Re: Revised Work Plan
Cabot Carbon Site, Gainesville Florida

**Revised Supplemental Groundwater Quality
Characterization Work Plan**

**Cabot Carbon/Koppers
Superfund Site
Gainesville, Florida**

FIGURE A-1
Lateral Extent of Capture Zone of Groundwater Interceptor Trench in Surficial Aquifer (Weston, 2006)

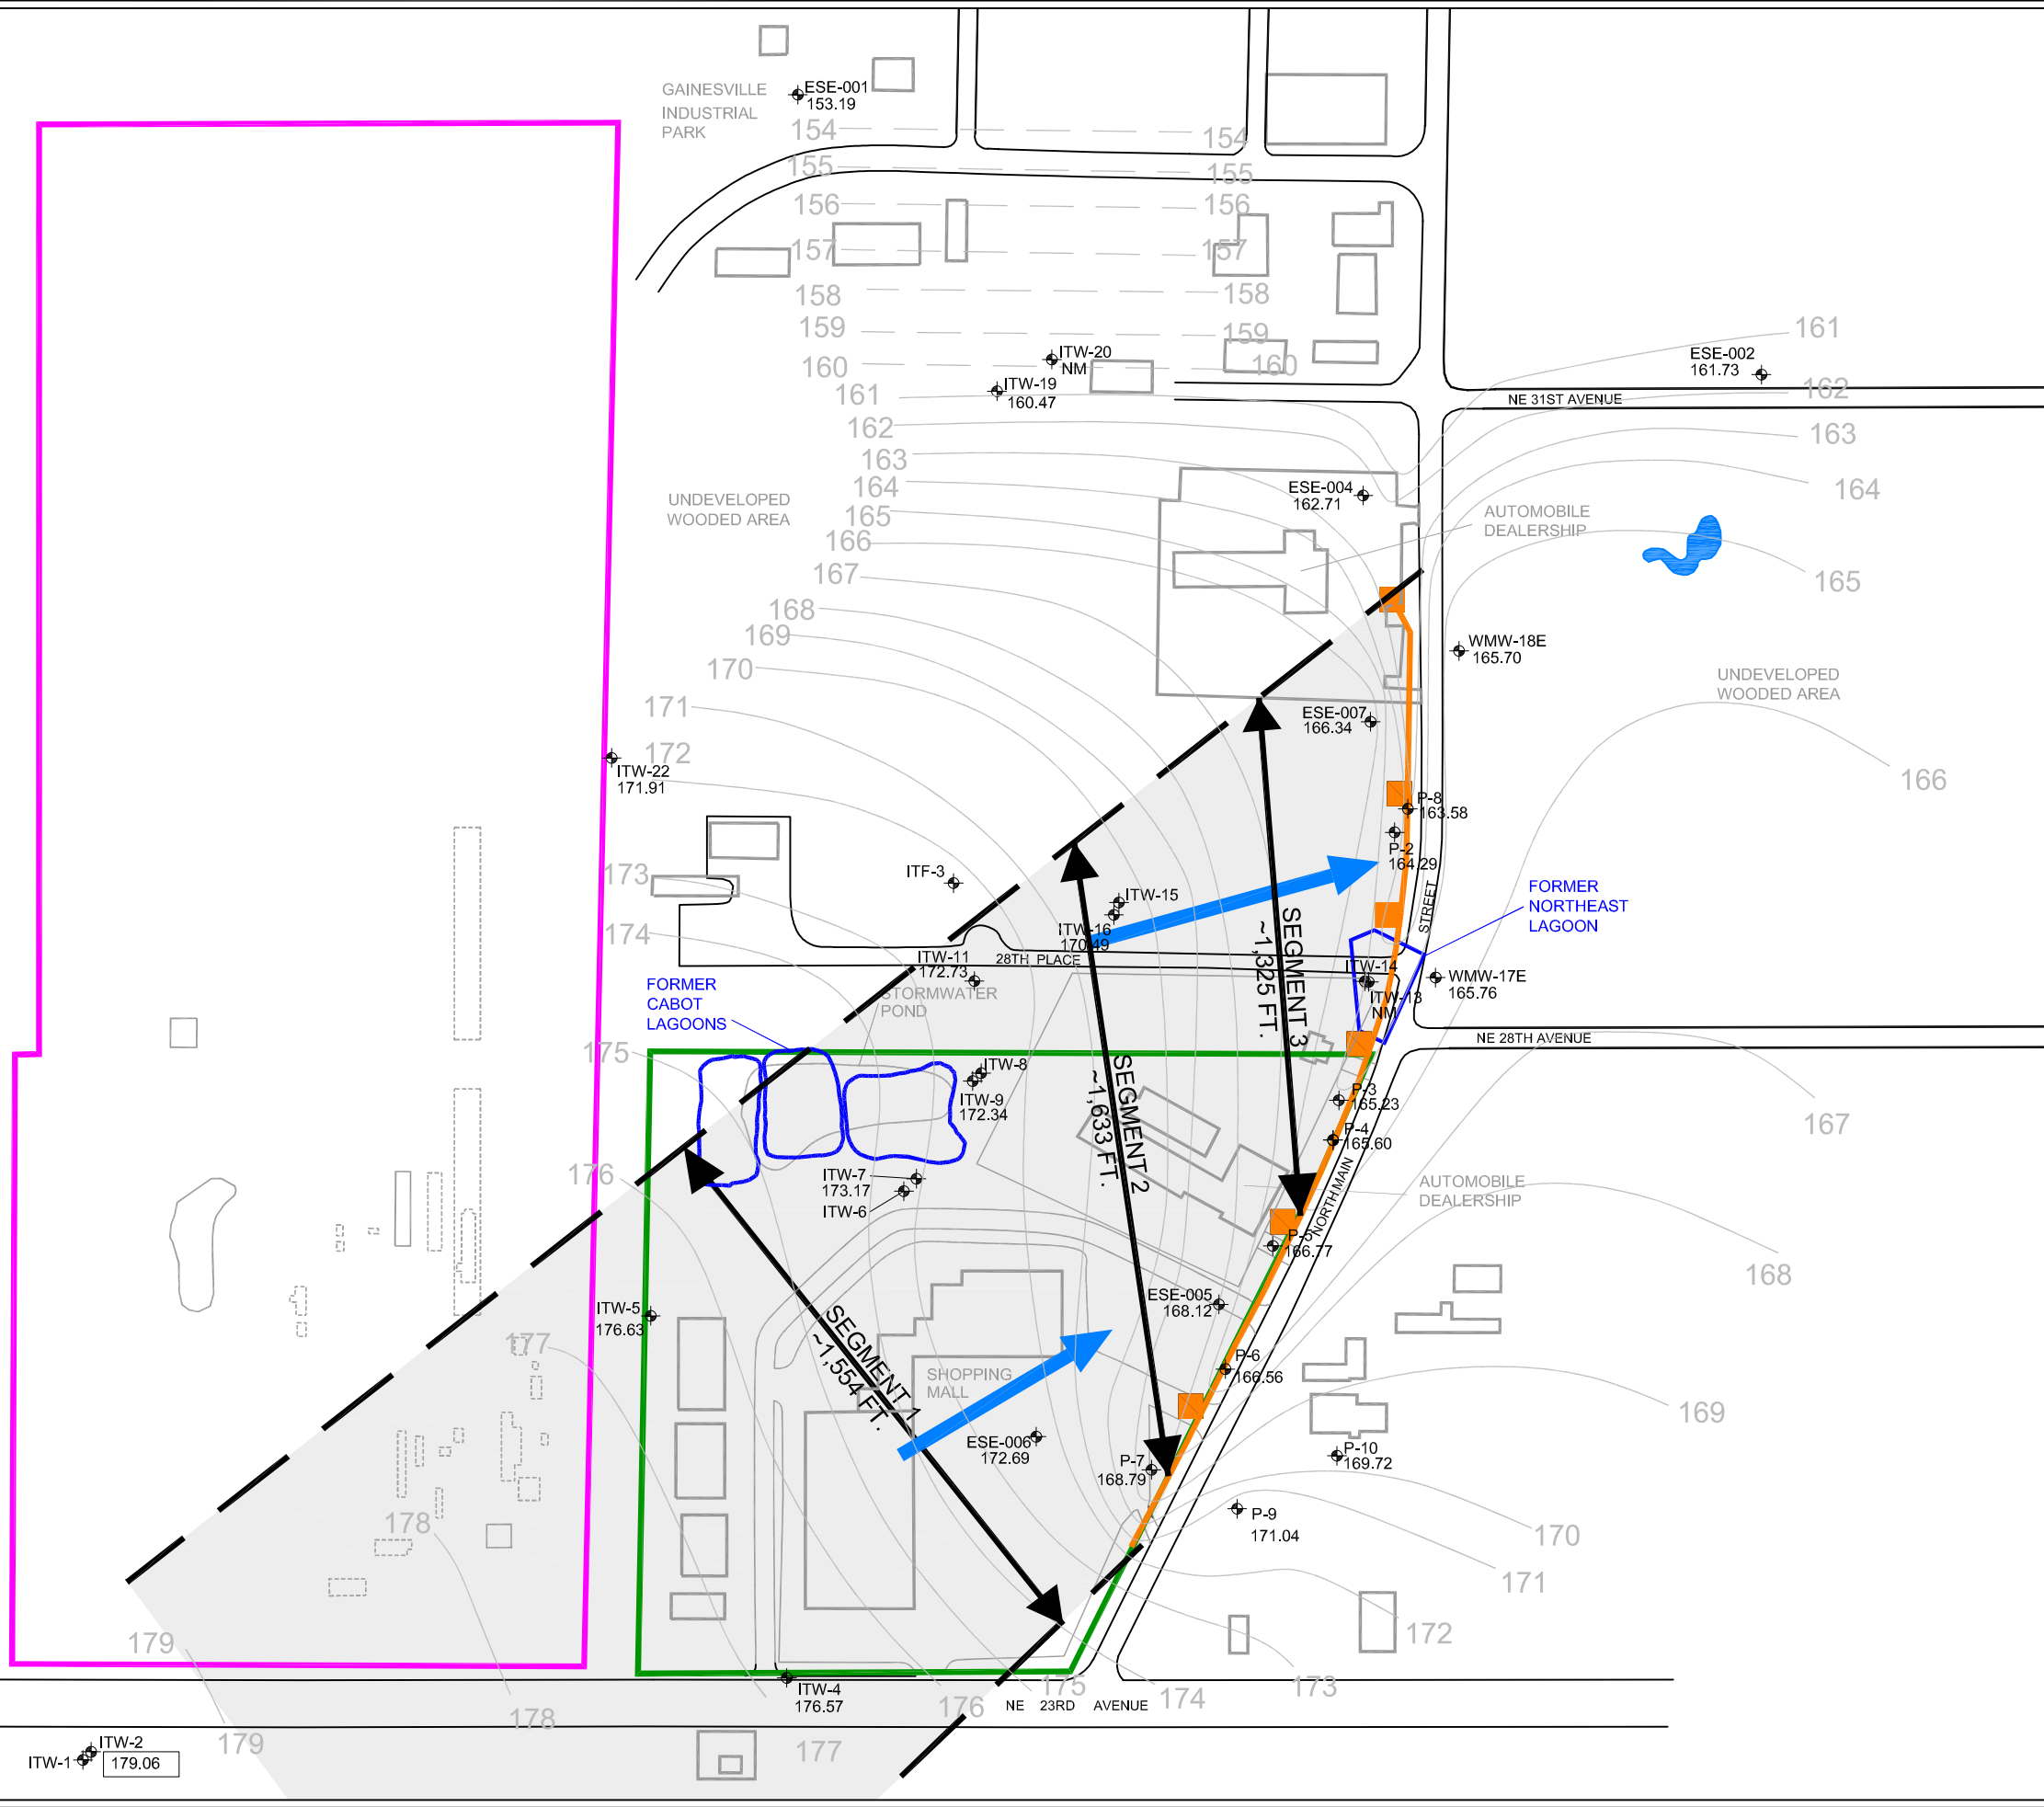
Issue: USEPA raised concern regarding the effectiveness of the Cabot interceptor trench to capture contaminated groundwater at the base of the surficial aquifer and requested that Cabot perform depth-discrete profiling of water quality to demonstrate trench effectiveness.

- Finally, the post-remedy groundwater quality data discussed above are consistent with groundwater flux calculations that were performed to evaluate whether the trench was capturing the entire thickness of the surficial aquifer. Calculations indicate that the vertical extent of the trench capture zone ranges from 37 to 40 feet, which is greater than the thickness of the surficial aquifer (Attachment A). Note, these calculations utilized an average groundwater extraction rate at the trench of 47 gpm and a (WHI-defined) hydraulic conductivity of 21 ft/day for the surficial aquifer, and a range of values for hydraulic gradient (6.95×10^{-3} to 8.95×10^{-3} ft/ft) and capture zone widths (1,325 to 1,554 feet) (see Attachment A).
